From: <tfohara@dukeengineering.com>
To: Goutam Bagchi <GXB1@nrc.gov>
Date: Wed, Mar 29, 2000 4:10 PM
Subject: Some thoughts on draft technical document & truncation

Comments on NRC "Draft Final Technical Study of Spent Fuel Pool Accident Risk at Decommissioning Plants" – February 15,2000**Summary of NRC Draft**

Comments on Appendix 2b Structural Integrity of Spent Fuel Pools Subject to Seismic Loads (Reference 1)**1. Introduction**

Figure 1 – Distribution of Upper Bound Magnitude Estimates from Reference 1 for a New England site.

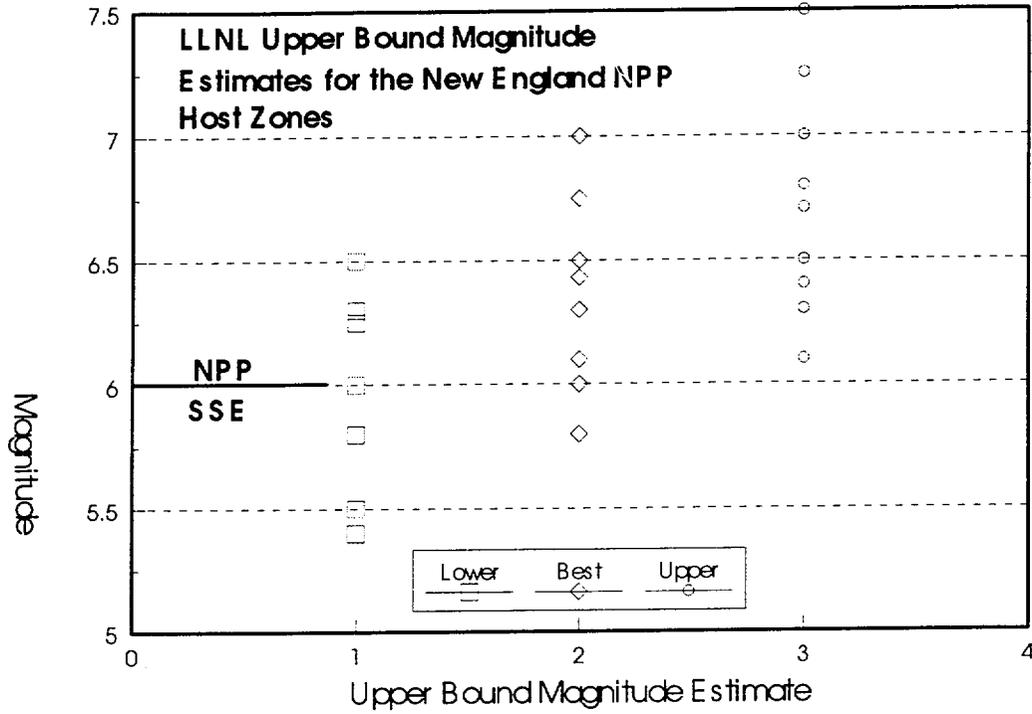
the assumption of the largest event geophysically ascribable to a tectonic province or to a capable structure at the closest proximity of the province or fault to the site. In the case of the tectonic province in which the site is located, the event is assumed to occur at the site. For the Eastern seaboard, the Charleston event is the largest magnitude earthquake and current research has established that such large events are confined to the Charleston region. The New Madrid zone is another zone in the Central US where very large events have occurred. Recent research has identified the source structures of these large New Madrid earthquakes. Both of these earthquake sources are fully accounted for in the assessment of the SSE for currently licensed NPPs. The SSE ground motions for NPPs are based on conservative estimates of the ground motion from the largest earthquake estimate to be generated from the current tectonic regime. For CEUS sites the typical NPP is designed for about a magnitude 5.3 to 5.5 (about 0.15g). The largest design basis earthquake for a CEUS site, based on detailed seismological, geological, and geophysical investigations, is magnitude 6.0 (about 0.25g). In no EUS licensing proceeding has there been compelling data to require design to an earthquake of a magnitude which would challenge the seismic capacity of an SFP that satisfies the seismic checklist. For WUS sites the design basis ground motion is generally governed by known active faults at known distances. Based on fault length and other deterministic factors the maximum earthquake potential can be estimated.

Figure 2 Effect of Attenuation Random Uncertainty on Probability of Exceedance from a Point Source

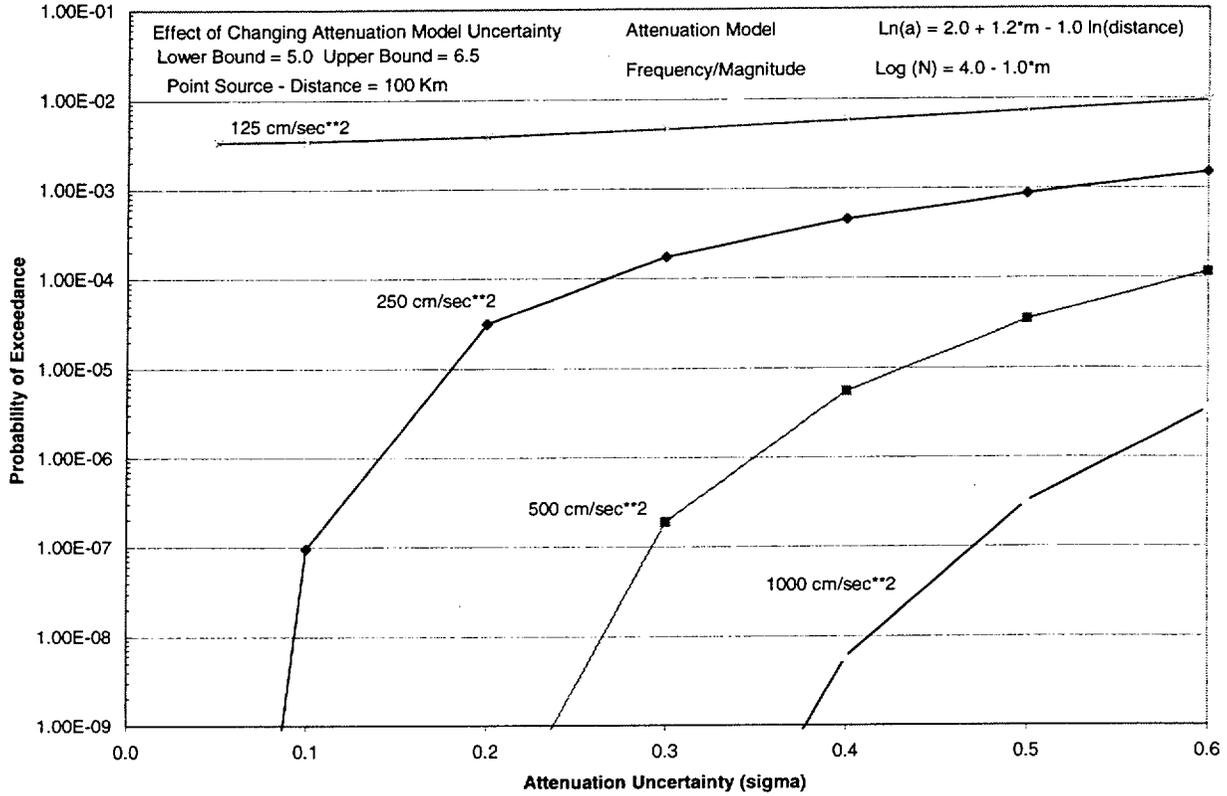
Goutam - attached are some comments on the draft technical document. Included in the text is a discussion on the effect of the attenuation model random uncertainty term. I was able to analytically model a point source and show the effect of how changes in sigma change the probability of exceedance at various ground motion levels. The bottom line is that at high ground motions, the probability of exceedance is driven by the extreme tail of the distribution.

It was noted previously that a 0.5g HCLPF relates to about a 1 g median SFP capacity. When rigorously convolving a typical mean seismic hazard curve with the SFP fragility curve associated with a 0.5g HCLPF, the dominant contribution to the seismic risk occur above about 0.7g. Based on this information, only large earthquakes can generate ground motions of the amplitude, frequency content, and duration to challenge the seismic capacity of spent fuel pools. However, at high ground motion values (1g), the tail of the attenuation random uncertainty distribution (sigma) allows, with some non-negligible probability, relatively small events to contribute to the probability of exceeding a ground motion of 1g. Deterministic evaluation performed in the licensing of CEUS NPPs have not identified any sources near NPPs that are capable of generating earthquake ground motions of this magnitude. Therefore, these probabilistic results don't make sense and provide a basis for truncating the tail of the random uncertainty term at high ground motion values or using a smaller value for the random uncertainty term at high ground motions.

Figure 3 – Annual Probability of Exceeding the SSE at CEUS sites based on EPRI (Reference 3)

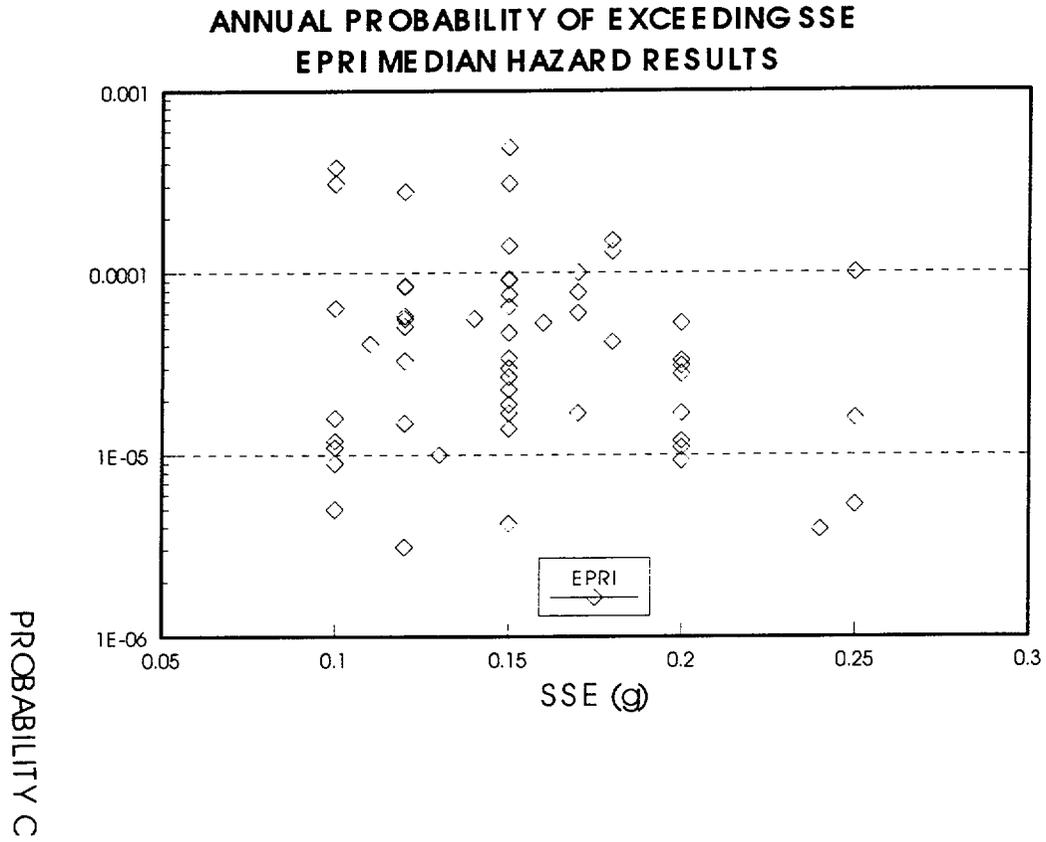
earthquakes to the overall seismic hazard, not on the absolute effect. Also, comparisons between the LLNL and EPRI results was typically made at the SSE level (0.15g to 0.25g - annual probability of 10^{-3} to 10^{-4}), not at the ground motion level associated with a HCLPF of 0.5g. It is noted that given a HCLPF of 0.5g the median capacity (A_m) of an SFP is about 1.0g ($A_m = \text{HCLPF}/e^{-1.65(Bc)}$) – far from typical SSE values. Realistically, only large Charleston like earthquakes can generate ground motions of the amplitude, frequency content, and duration to challenge the seismic capacity of spent fuel pools. However, at high ground motion values (1000 cm/sec²), the tail of the attenuation random uncertainty distribution (sigma) allows, with some non-negligible probability, relatively small events to contribute to the probability of exceeding a ground motion of 1000 cm/sec². Figure 2 shows the effect of changing sigma for a point source at a given distance. These results were analytically determined. As can be seen, at low ground motions (125 cm/sec²), changes in sigma have a small effect on the probability of exceedance. However, at high accelerations (1000 cm/sec²) the effect of changes in sigma is profound. The high probability of exceeding 1000 cm/sec² based on use of a sigma of 0.6g in Figure 2, is driven by the tail of the attenuation random uncertainty term. For example, 1000 cm/sec² is about 3 standard deviations above the expected ground motion from a magnitude 6.5 earthquake at 100 km. Deterministically, these results don't make sense and provide a basis for truncating the tail of the random uncertainty term at high ground motion values. Use of a smaller sigma value is a form of truncation. As can be seen on Figure 2, the probability of exceeding 1000 cm/sec² is reduced by about a factor 600 by simply changing sigma from 0.6 to 0.4. EPRI results are based on use of a sigma of 0.5. Based on this information and information previously described in Reference 5, use of the LLNL probabilistic estimates at low probability values may not be credible. EPRI results are also likely to be overly conservative at high ground motion values.
